ADDENDUM NO. 3

BDVWA WATER SYSTEM IMPROVEMENTS AND CONSOLIDATION PROJECTS

October 16, 2026

ADDENDUM 3
October 16, 2026

DRAWING NUMBER
C001
3 / 32

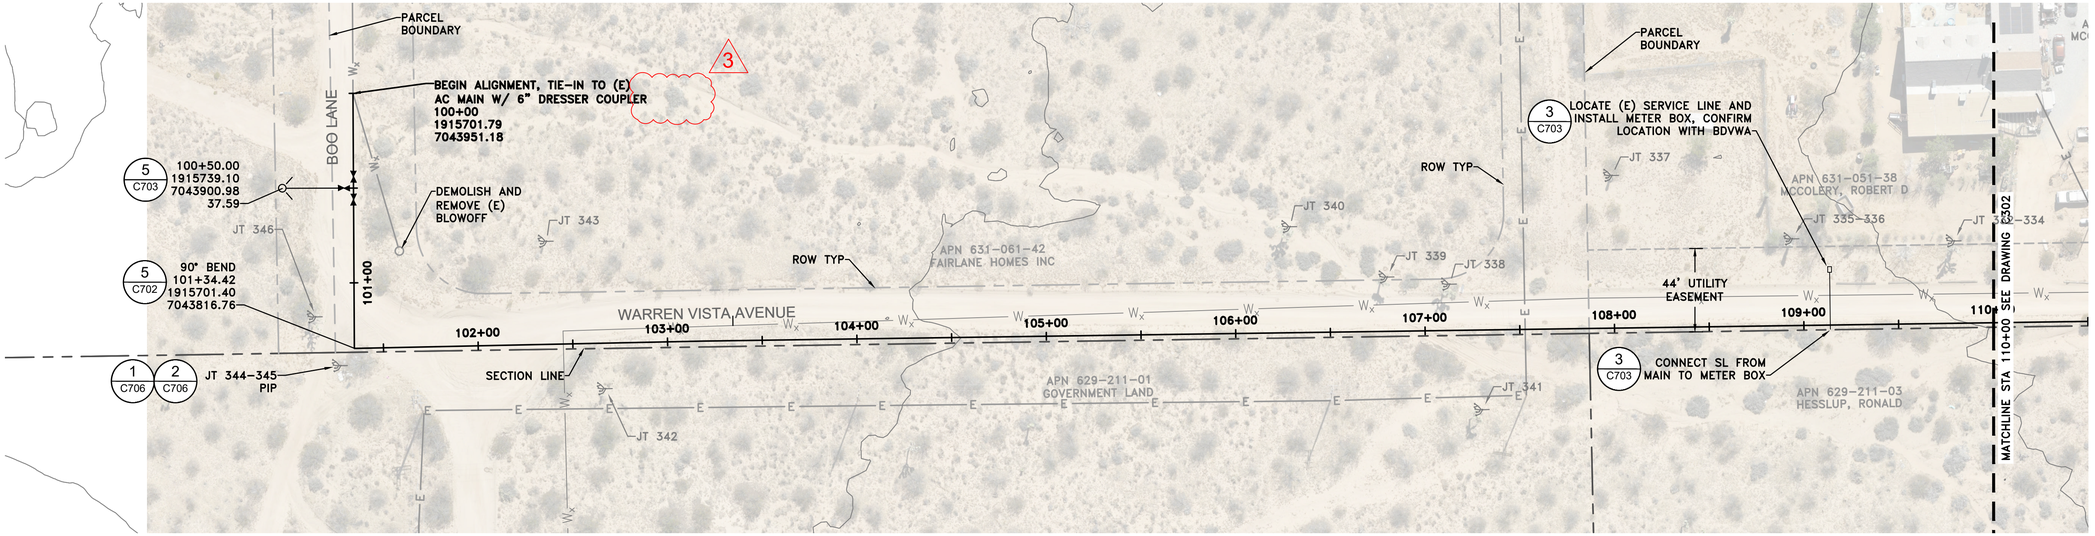
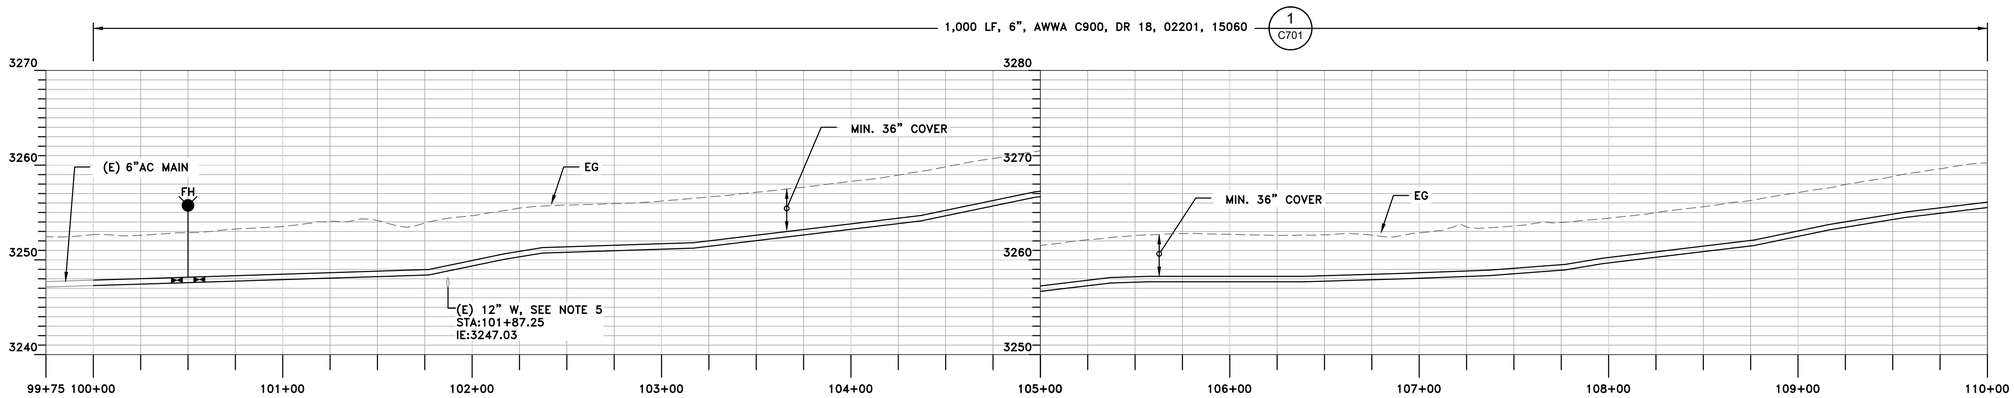
Item No.	Drawing No.	Description
1	Vol. 1 – C001	Add “ABANDON” to legend.
2	Vol. 1 – C301	Delete “3/C704” detail reference.
3	Vol. 1 – C401	Replace “DR 14” with “DR VARIES” on profile annotation.
4	Vol. 1 – C402	Replace “DR 14” with “DR VARIES” on profile annotation.
5	Vol. 1 – C403	Replace “DR 14” with “DR VARIES” on profile annotation.
6	Vol. 1 – C701	Common trench detail 2 revised to include callouts for each of the pipes to indicate required wall thickness and identify each pipe relative to looking in an eastward direction.
7	Vol. 3 – M-05	Dimensions added to the depth and inside diameter of the existing can of Sectio B detail.

PROJECT: 072-01
DATE: OCTOBER 2026
DRAWING NUMBER
C301
15 / 32

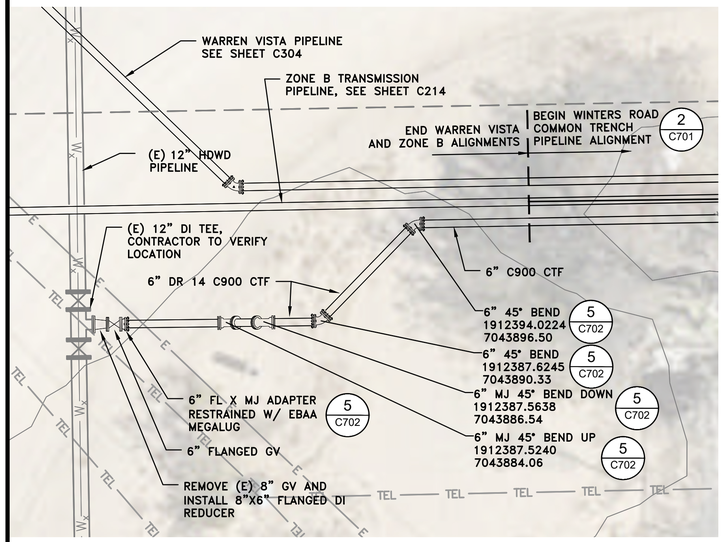
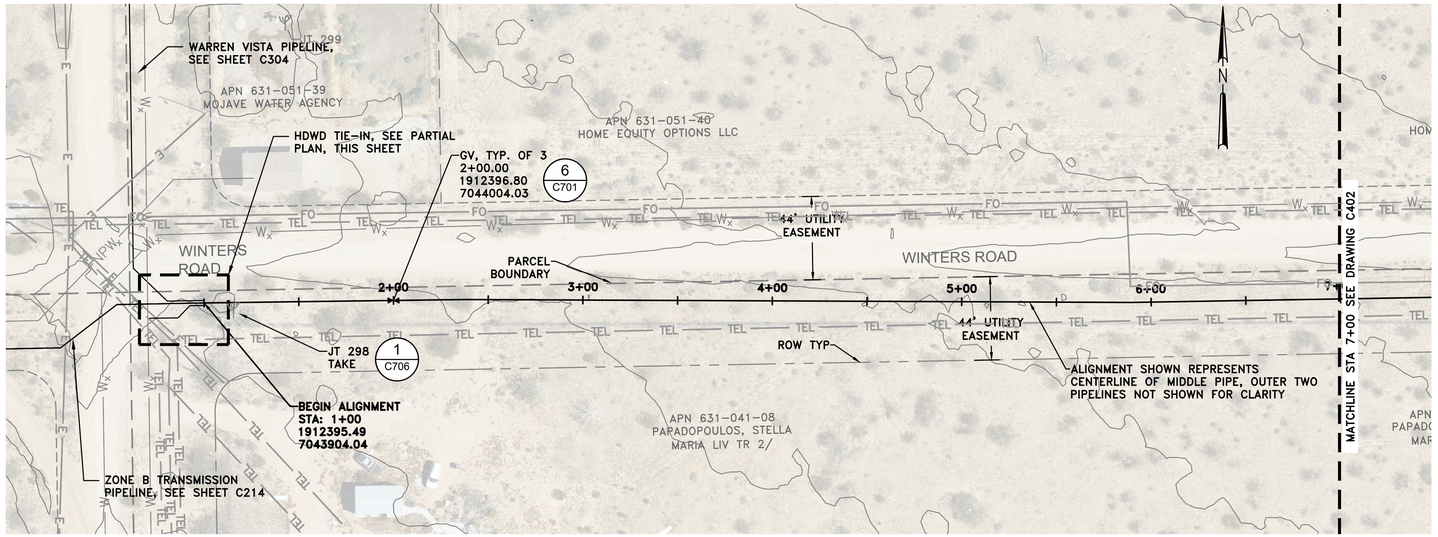
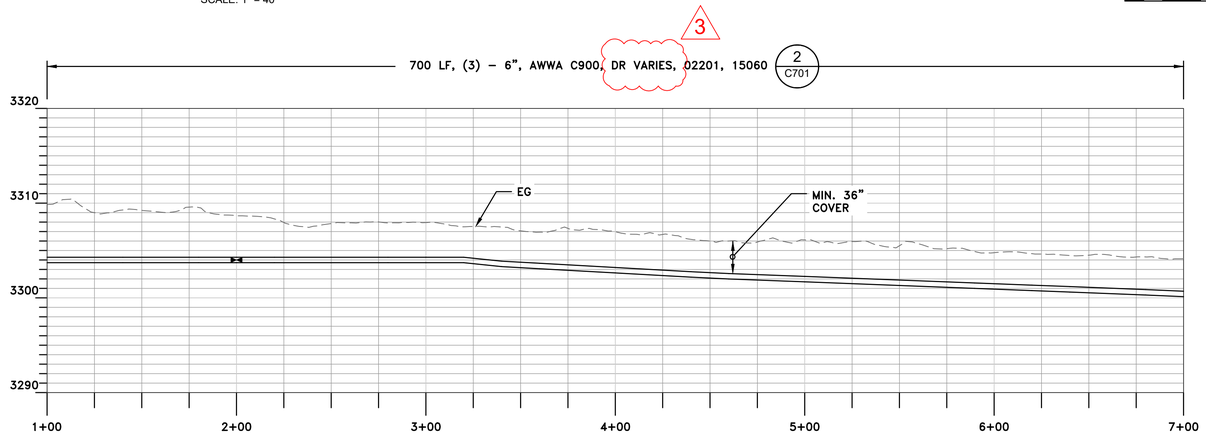
1	**Question:** *Pipe class, Items 7, 8 and 10: The bid items and Section 01150 call for 6" DR 14 C900, but the profiles on C301-C304 (Warren Vista), C601 (Lanes End) and a plan note on C403 (Winters Rd) call out DR 18. Which class should bidders price? Unless directed otherwise, we'll price DR 14. Also, the C601 label says 1,000 LF while the alignment is about 705 LF. Please confirm 705 LF is correct.* **Answer:** **All Pressure Zone D pipelines, including Warren Vista, Lanes End, Rainbow Drive, and the northern pipeline within the common trench on Winters Road, shall be C900 DR 18. Bid Items 7, 8, 9, and 10 in Section 01150 have been revised by this Addendum accordingly. The Zone B Transmission Main and HDWD pipeline shall be C900 DR 14. Within the common trench on Winters Road, the Zone B Transmission Main is the center pipeline and the HDWD pipeline is the southern pipeline; the Pressure Zone D pipeline is the northern pipeline. Drawings C401, C402, C403, and Detail 2 on C701 have been revised to reflect these requirements.** **The correct Lanes End pipeline quantity is 705 LF. The label on Drawing C601 has been revised accordingly.**

D1 PUMP STATION IMPROVEMENT PLAN
1" = 2' - 0"

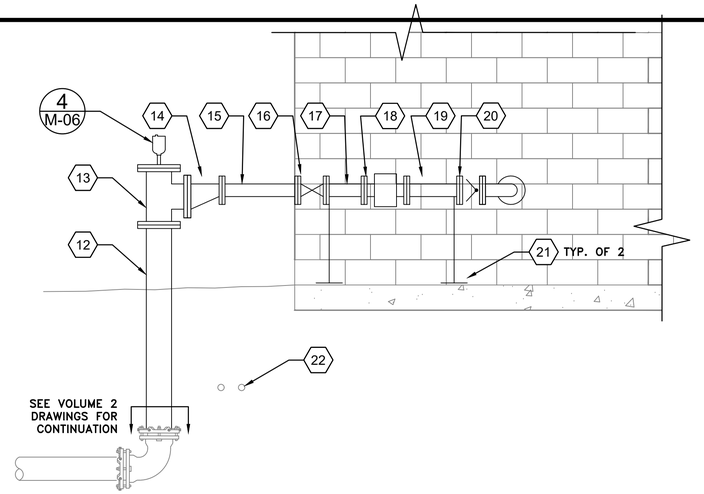
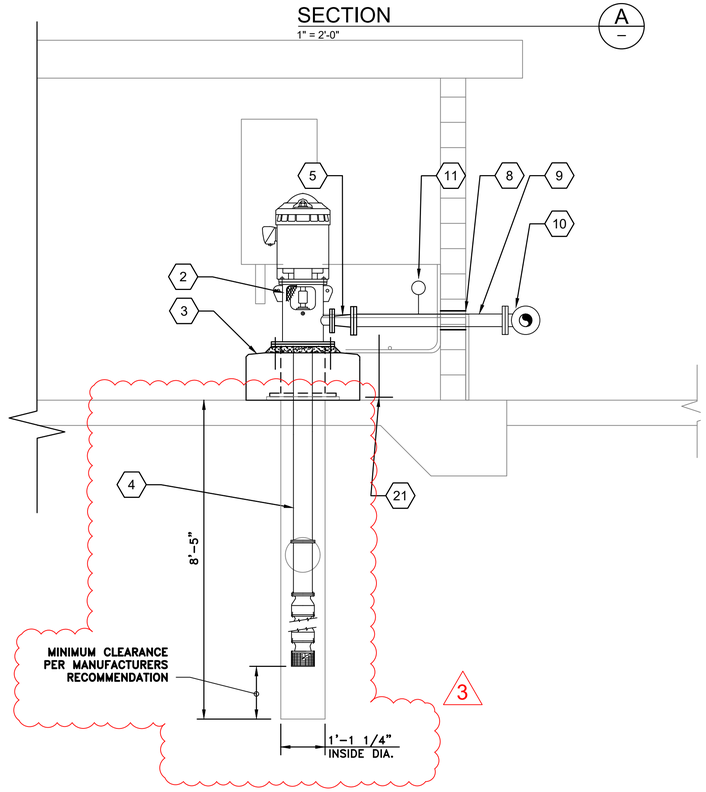
17	**Question:** *Can you please provide the total pump length for the vertical turbine pump described in section 11900? The pump is shown on drawing M-05, but this does not show the complete pump with the necessary dimensions. Pump length is a critical measurement in quoting pumps of this type.* **Answer:** **Drawing M-05 has been revised (see attachments) to include the dimensions of the existing wet well. The overall pump length is not prescribed in Section 11900. The Contractor shall furnish a vertical turbine pump that meets the performance requirements specified in Section 11900 and is dimensionally compatible with the existing wet well, including its inside diameter, depth, and required suction screen clearance. The final pump dimensions and installation configuration shall be provided in the Contractor's equipment submittal.**
18	**Question:** *I had a quick question about one of the pages included in the Bid Forms, specifically page 12 Debarment and Suspension Certification (attached). We do not keep an attorney on retainer; can we self-certify this form?* **Answer:** **Yes. The Debarment and Suspension Certification may be executed by a duly authorized representative of the Contractor. An attorney's signature or affirmation is not required. The Bid Forms have been revised to remove the attorney affirmation requirement and are attached in their entirety to this Addendum for clarification.**
